CORRIGENDUM-II

Ref. Tender No. BGL/327/2016-17 dated.21.09.2016

Sub: Tender for Rate Contract for Mechanical & Electrical works for construction of CNG DBS & Online Stations in Hyderabad, Vijayawada & Kakinada.

OWNER					
M/s BHAGYANAGAR GAS LTD.					
TITLE:					
SINGLE LINE DIAGRAM					
SOR ITEM NO: 2-2					
DESIGN	REVISION	CHECKED	APPROVED	SCALE	DATE
C TRIPATHY	0	SHANKAR RAJ		NTS	06.03.2012
DRG. NO: PANEL/DELTA/002				SHT. No. 1 OF 1

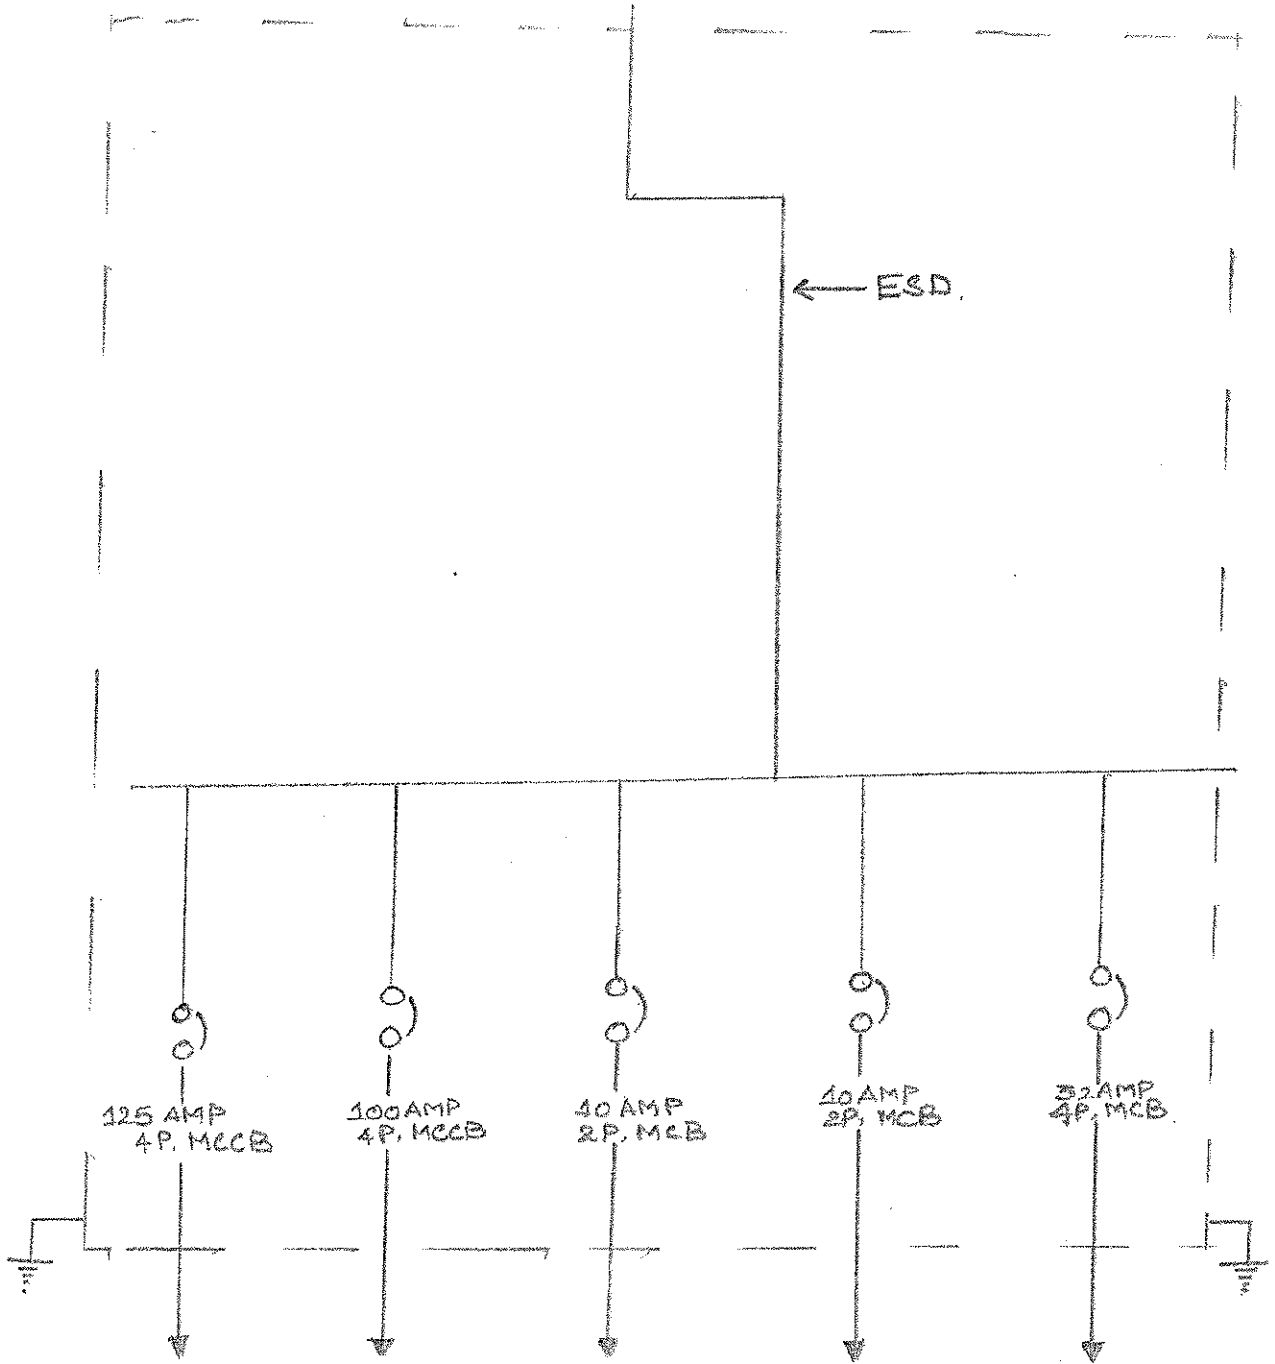
5	Vol II of II, Section-9 SOR (Page 48 of 66)	SOR item nos: 2.1 & 2.2	Panel drawing and size specification not mentioned	Enclosed as Annexure-I
6	Vol II of II, Section-9 SOR (Page 49 of 66)	SOR item nos: 5	Drawing not provided for IS:3043 earthing	Enclosed as Annexure-II
7	Vol II of II, Section-9 SOR (Page 49 of 66)	SOR item nos: 7	Shunt trip coil in item no: 4 to be provided	To be read as item no 2.1 & 2.2 of SOR
8	Vol II of II, Section-9 SOR (Page 49 of 66)	SOR item nos: 11	Thickness of Pipe not mentioned	PVC pipe to be used for cable conduiting shall be as per standard practise of Electrical cable laying
9	Vol II of II, Section-9 SOR (Page 51 of 66)	SOR item nos: D.a)	Size of the frame not mentioned	Frame shall be made of 25mmx3mm flats of frame sizes as per BGL requirement which shall be intimated during execution.
10	Vol II of II, Section-9 SOR (Page 48 of 66)	SOR item nos: 2.1	supply, erection and commissioning of sub distribution board with incomer 125 Amp , 4P MCCB and outcomer having one number 100 Amp DP MCB (Make of SWITCHGEAR should be of L&T or LEGRAND or CG), the panels must be provided with a suitable emergency shutdown button which can be fixed at outside the control room and near to the sales/dealer room, jobs must include all the accessories required for connecting the required load details given alongwith SOR as directed by EIC.	To be read as supply, erection and commissioning of sub distribution board with incomer 125 Amp , 4P MCCB and outcomer having one number 100 Amp, 4P MCCB and 02 no's (Two) numbers of 10 Amp DP MCB, 01 no's (One) 16 Amp, 4P MCB (Make of SWITCHGEAR should be of L&T or LEGRAND or CG), the panels must be provided with a suitable emergency shutdown button which can be fixed at outside the control room and near to the sales/dealer room, jobs must include all the accessories required for connecting the required load details given alongwith SOR as directed by EIC.

2.2	<p>supply, erection and commissioning of sub distribution board with incoer 400 Amp, 4P MCCB and four numbers of 10Amp DP MCB (Make of SWITCHGEAR should be of L&T or LEGRAND or CG), the panel should have Ammeter(o-500/5Amps), Voltmeter(0-500V) with selector switches. The panels must be provided with a suitable emergency shutdown button which can be fixed at outside the control room and near to the sales/dealer room jobs must include all the accessories required for connecting the required load details given alongwith SOR as directed by EIC</p>	<p>To be read as supply, erection and commissioning of sub distribution board with incoer 400 Amp, 4P MCCB and 02 no's of 10Amp DP MCB, 01 no's of 32Amp 4P MCB (Make of SWITCHGEAR should be of L&T or LEGRAND or CG), the panel should have Ammeter(o-500/5Amps), Voltmeter(0-500V) with selector switches. The panels must be provided with a suitable emergency shutdown button which can be fixed at outside the control room and near to the sales/dealer room jobs must include all the accessories required for connecting the required load details given along with SOR as directed by EIC</p>
